**RESPONSE TO REQUEST FOR ADDITIONAL INFORMATION ON THE
DRAFT SECTION 3116 DETERMINATION
IDAHO NUCLEAR TECHNOLOGY AND ENGINEERING CENTER
TANK FARM FACILITY**

March 16, 2006

CH2M♦WG Idaho
Idaho Falls, Idaho 83403

Figure 7-16. Extent of perched water due to non-flooding conditions and flooding conditions (saturated conditions are denoted as red).^d

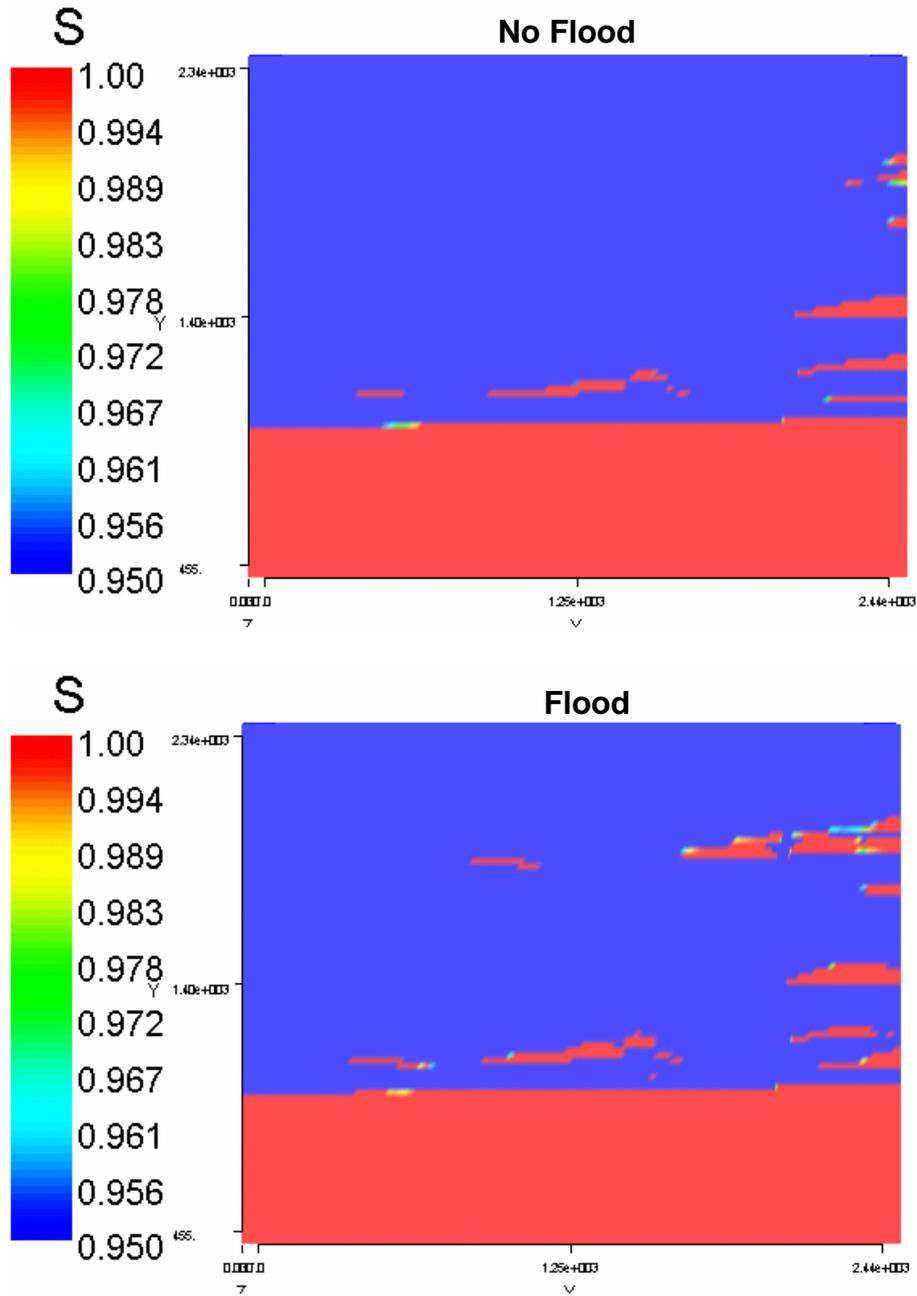
The NRC notes that PA Section 2.1.5.3.6 states “The flood hydrograph for the base-case discharge shows a peak flow that lasts only 7.5 hours (Figure 2-19).” The NRC also notes that the PA states “Since the INTEC facility is located at the boundaries of the flood, the area would be inundated for a lesser period of time (p. 2-38).” The NRC states “The information conveyed in the second sentence called out above does not necessarily follow from the information conveyed in the first sentence: The duration of peak discharge does not necessarily imply how long water may pond at the surface of the TFF or elsewhere (see also Section 7.4.2, page 7-26).” The INL agrees with NRC that the statement is in error. The peak flow rate duration is not an indication of how long water may pond at the TFF. The peak flow rate would be expected to be less at the margins of the flood channel.

Peak concentrations at the water table are lower for a flooding scenario compared with steady-state simulations. Larger floods provide more water for recharge and subsequent dilution of contaminants. The PA (see Figure 7-16; attached) shows the impact on perched water zones due to the PMF flooding event. The increase in the number, size, and location of perched water zones will increase the dilutions of the contaminants.

The NRC’s concern that an increase in the ponded water residence time will result in higher infiltration rates and subsurface transport is addressed in Section 7 of the PA. Large-scale increases in recharge, due to a major flooding event, will result in a dilution effect as illustrated in the PA (see Figure 7-15; attached). Peak concentrations at the water table are lower for a flooding scenario compared with steady-state simulations. Concentrations for the flooding scenario after the peak has been reached are slightly higher than the steady-state simulation due to the large lateral spreading of the contaminant in the increased perched water zones. However, these small concentration increases in the later years are still bounded by the PA analysis. Larger floods provide more water for recharge and subsequent dilution of contaminants. The PA (see Figure 7-16; attached) shows the impact on perched water zones due to the PMF flooding event. The increase in the number, size, and location of perched water zones will increase the dilutions of the contaminants.

Figure 2-20. Basalt moisture characteristic curve and pressure versus saturation curve.^{aa}

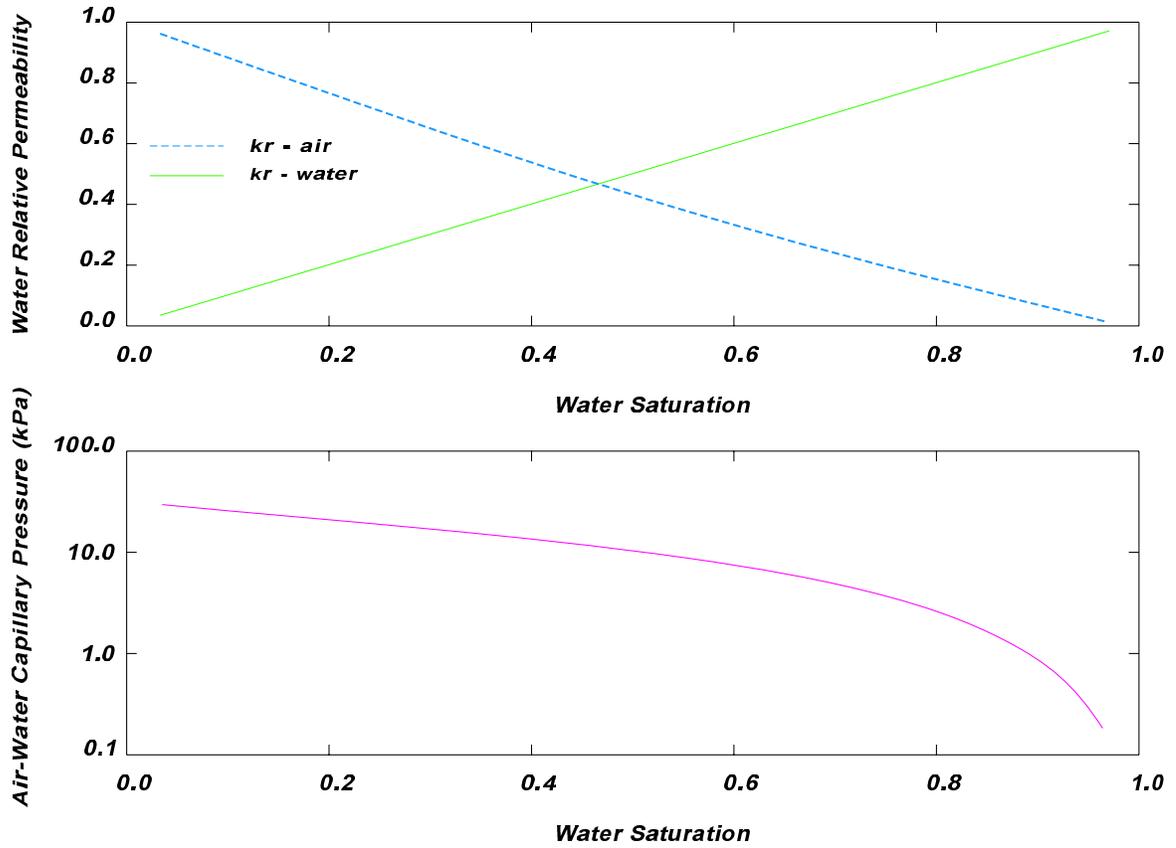
Figure 2-20 (DOE-ID, 2003b) presents relative permeability and moisture characteristic curves based on data presented in Rodriguez, et al. (1997). It is unclear whether the constitutive relationships in Figure 2-20 was used for the TFF performance assessment (2003b). If the relationships in Figure 2-20 were used in DOE-ID (2003b), small pores and absorbed water films are neglected (i.e., there is no residual water saturation using this relationship) and water drainage begins instantaneously with capillary pressure decrease (i.e., there is no air-entry pressure using this relationship). It also appears that only drainage (but not imbibition) is modeled. If a relationship by Magnuson (1995) was used, as cited on page 7-32 (DOE-ID, 2003b), it is unclear how the relationship by Magnuson differs from the one shown in Figure 2-20. Please clarify what relationship was used in the modeling.

The constitutive relationships in Figure 2-20 (attached) were used for the basalts in the PA (DOE-ID 2003) groundwater analyses. There is no residual moisture content using the basalt curves (i.e., porous medium representation of the fractured basalts) shown in Figure 2-20 and water drainage in the fractures begins instantaneously with capillary pressure decreases. This approach is intended to represent the rapid water flow through the fractures and to support the conceptual model where water released from sedimentary interbeds moves rapidly through the basalts with little or no residual water left in the fractures. This is a conservative approach in that most of the water is rapidly moved through the fractures and no credit is taken for capillary barriers at the pore/fracture interface, water lost to dead-end fractures, or water absorbed to the fracture walls.

Figure 3-14. DUST-MS conceptual model for release from the TFF vaults and tanks.^{gg}

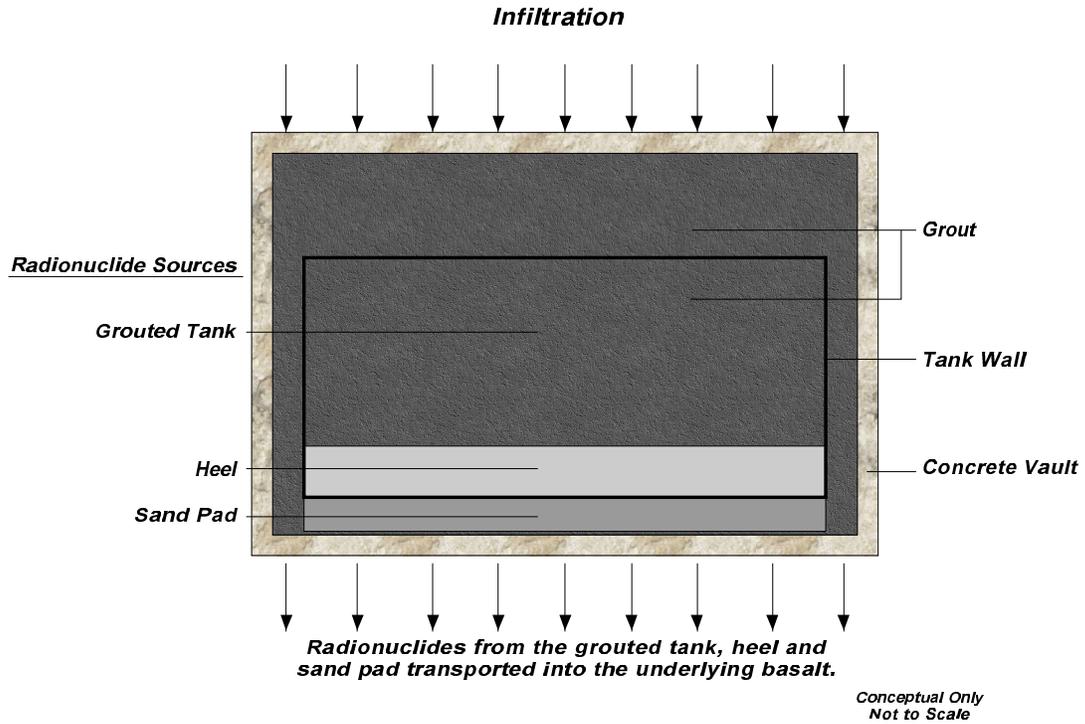
Figure 3-14 shows the conceptual model for the DUST-MS release modeling. The figure implies that release from the sand pad does not occur until the grouted tank fails at 500 years, i.e., there is a hydraulic barrier limiting infiltration to the sand pad until after 500 years. Please confirm that this conceptual model is for the tank release only.

Figure 3-14 (attached) of the PA (DOE-ID 2003) was presented only for conceptual purposes and shows the intact vault/tank system. This conceptual model is for the tank release only. No hydraulic barrier was assumed in the analysis for the sandpad releases. The sandpad releases were modeled beginning at 100 years post-closure in accordance with the degradation time assumption for the vault as described of the draft 3116 Determination. The sandpad releases were modeled in DUST-MS assuming that the material above the sandpad was not limiting the inflow of precipitation to the sandpad. In other words, the sandpad and the tank releases were modeled separately in DUST-MS. Assuming no limitation of infiltrating water to the sandpad at 100 years is considered conservative. In reality, the intact tank would provide some limitation of infiltration to the sandpad for 500 years.
